From: Steve Jones
Sent: Thursday, May 03, 2012 4:04 PM
To: Abigail Mayrena (AMayrena@regionalflood.org)
Cc: okwon@lasvegasnevada.gov; Todd Steadham (tsteadham@shg-inc.com)
Subject: RE: Kyle Canyon exhibits
Attachments: Exhibit J - Regional Facilities Map.pdf

From: Abigail Mayrena [<mailto:AMayrena@regionalflood.org>]
Sent: Monday, April 30, 2012 10:09 AM
To: Steve Jones
Cc: Oh Sang Kwon ,P.E. (okwon@lasvegasnevada.gov)
Subject: Kyle Canyon exhibits

EXHIBIT J

KYLE CANYON MASTER DRAINAGE STUDY (RFCDD SUPP)
CCRFCD REGIONAL FACILITIES MAP

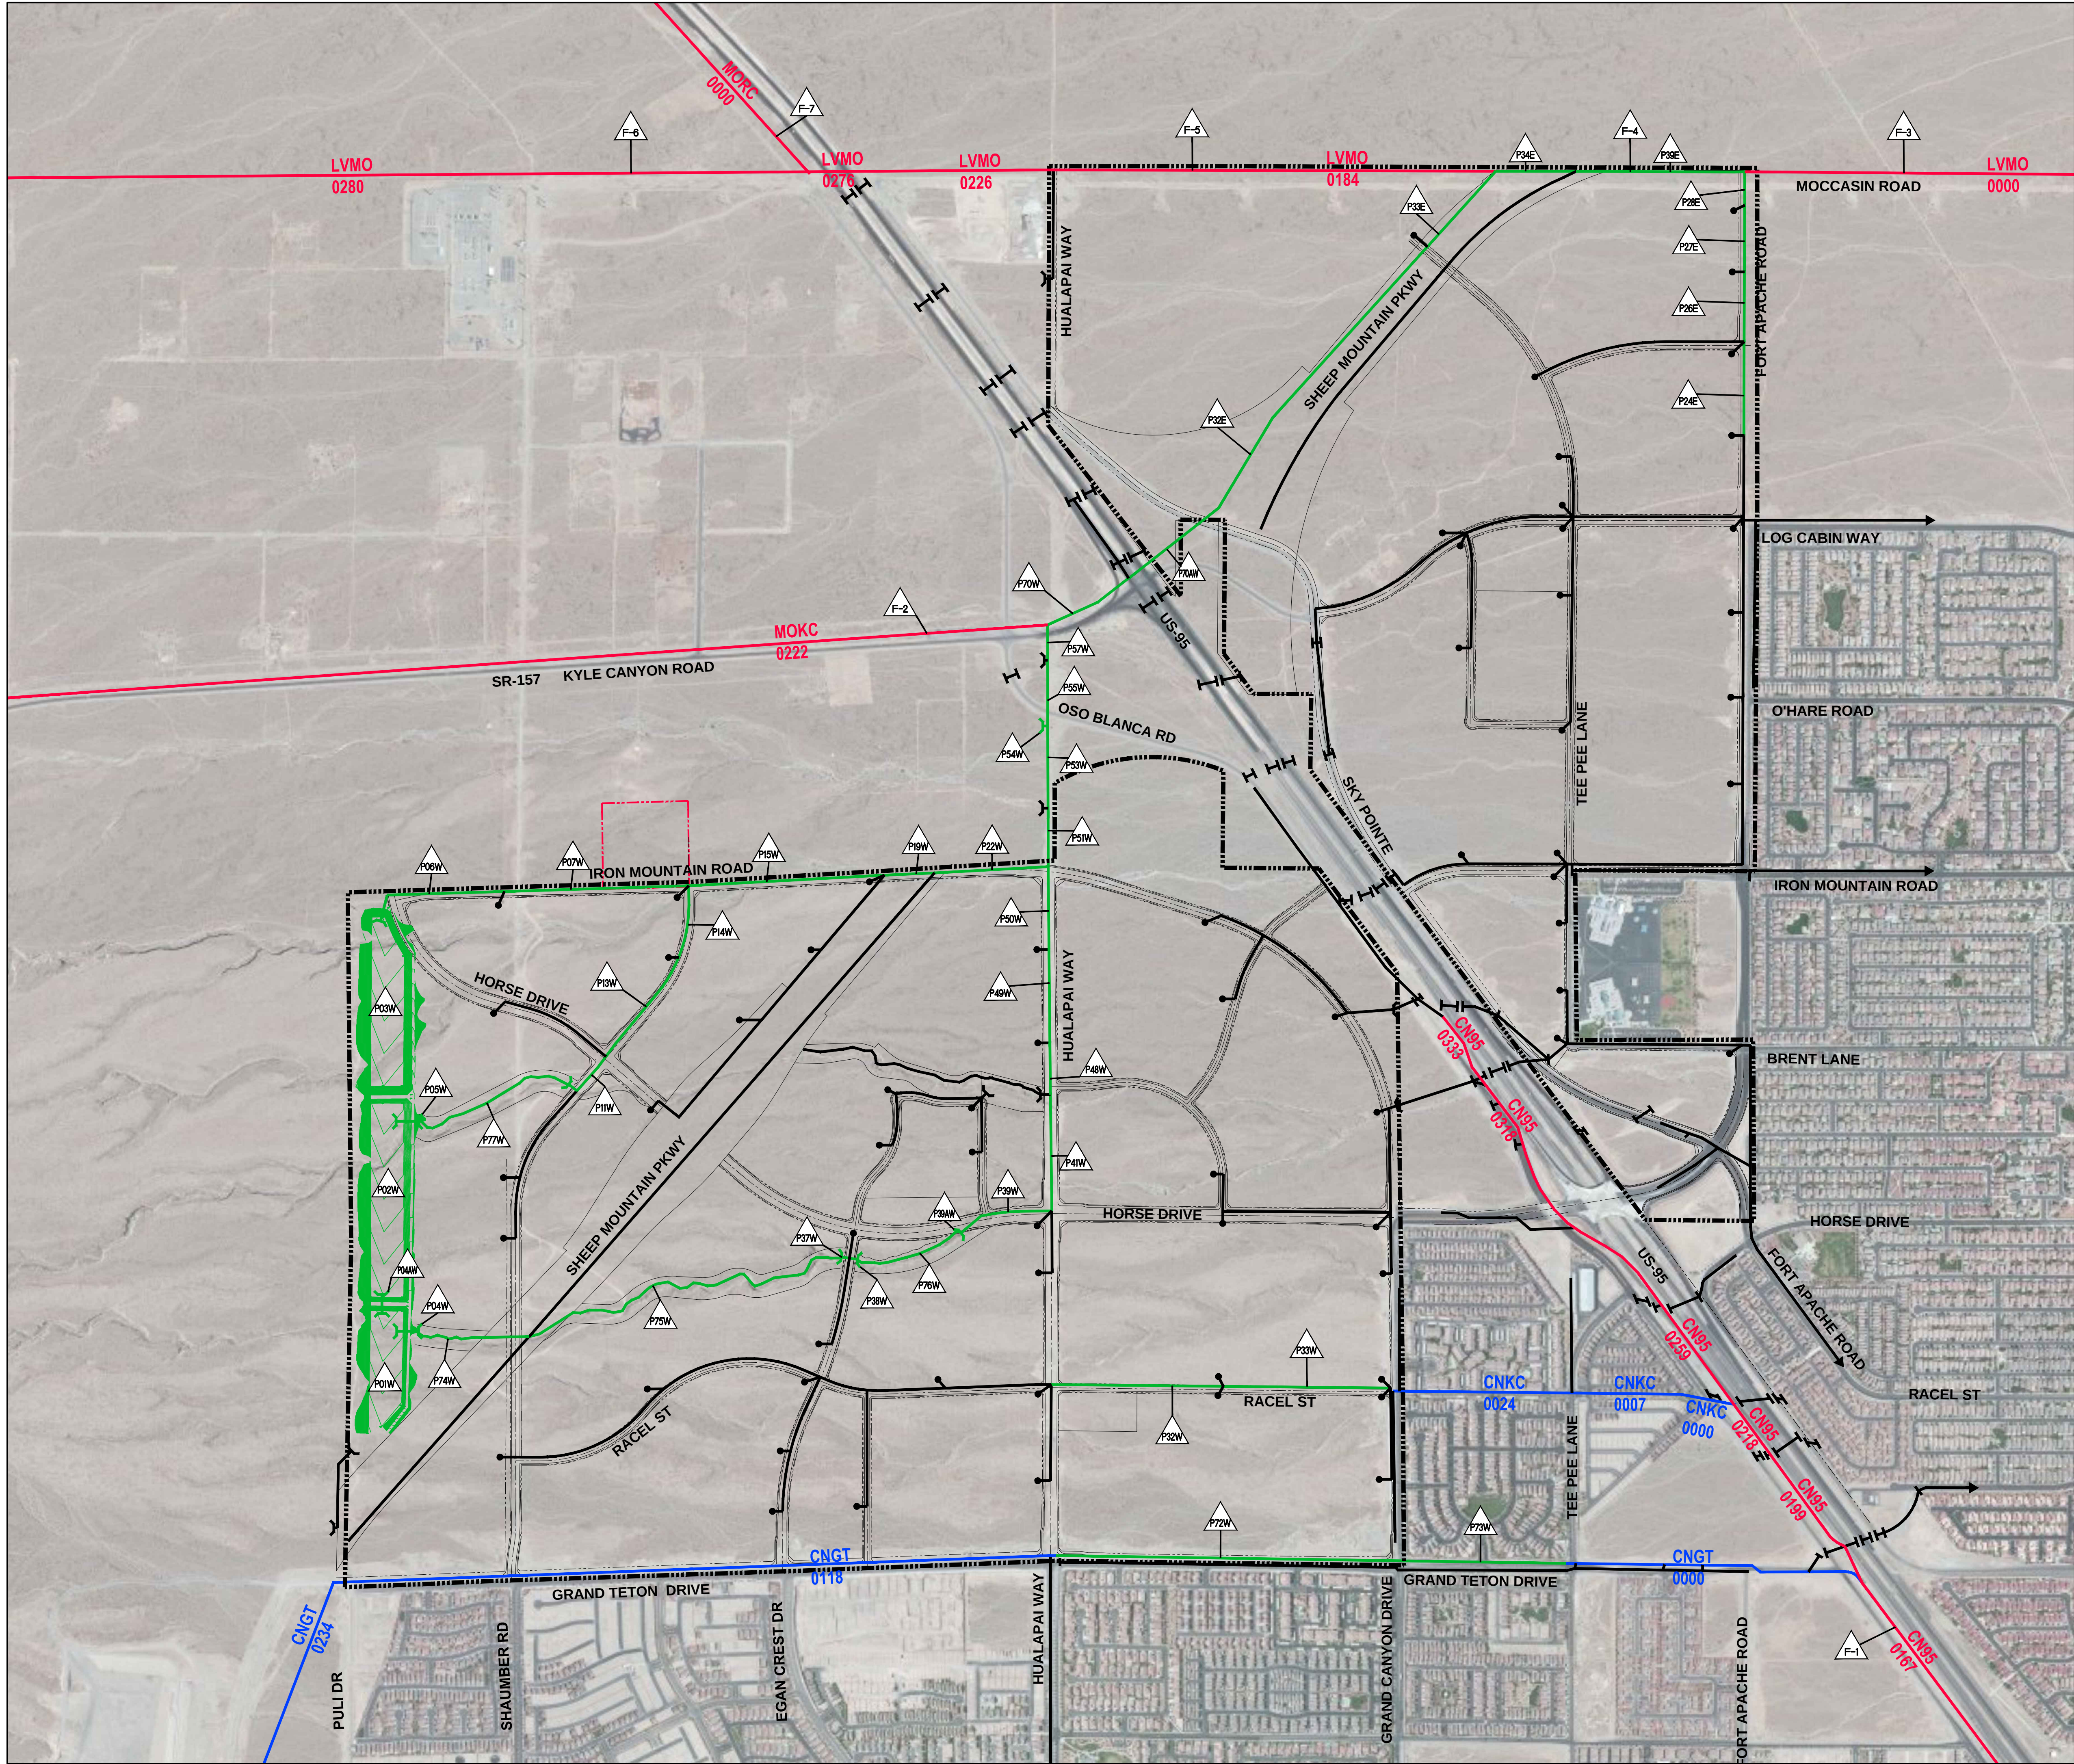
As discussed last week, can you revise U4 to be a Category B facility. I'll need the revised exhibits before I can process your concurrence letter. Can you also send the revised exhibits to CLV.

Facility U4 is intended to be constructed in the ultimate condition when Sheep Mountain Parkway is improved. Prior to Sheep Mountain Parkway improvements, the discharge from the regional detention basin Facility P01W (Facility P04W) is maintained in the existing southern arroyo and conveyed thru the Kyle Canyon site to the Hualapai Way alignment where it is conveyed north. Therefore, rather than revising the regional alignment after Sheep Mountain Parkway is complete and proposing a new developer financed (Category B) regional facility, Facility U4 has been changed to a future local facility and the regional alignment has been changed to match the proposed drainage condition presented in the CLV conditionally approved drainage study. Per the March 22, 2012 meeting with you and Andrew, this was determined an acceptable regional alignment to replace U4.

The attached Exhibit J and its summary table of West Regional Facilities has been updated accordingly. Note the only flow identified in the updated summary table that has not been updated is for Facility P22W; however, the flow reported and utilized for conceptual sizing of this facility included outflow from Detention Basin P01W which is considered conservative. Therefore, the reported flow and conceptual size for P22W is considered acceptable and the flow returns to as reported in the summary table at the next downstream facility (north of the intersection of Hualapai and Iron Mountain).
